Equipment Technical Bulletin

Summit Flush Manifold-Flow Switch/Manifold Pipe Connector

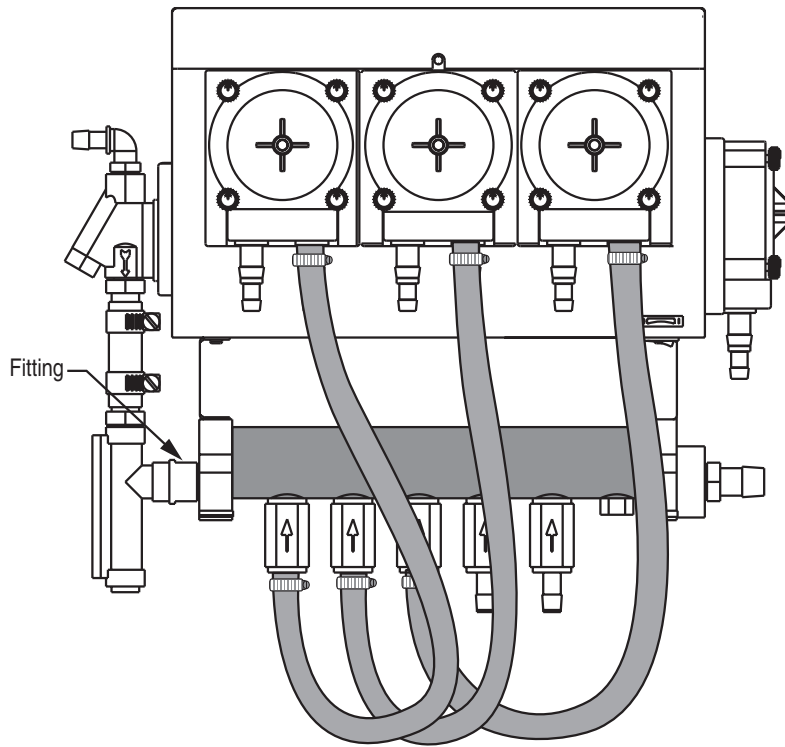
PROBLEM

The fitting that connects the flow switch to the manifold pipe breaks easily if installation instructions are not followed precisely.

SOLUTION

All units are now being produced with a brass connector, which is extraordinarily robust. Units which already shipped with the plastic connector are usable, but care needs to be taken during installation to follow the installation instructions carefully, since twisting the connector the wrong way can easily break the bracket.
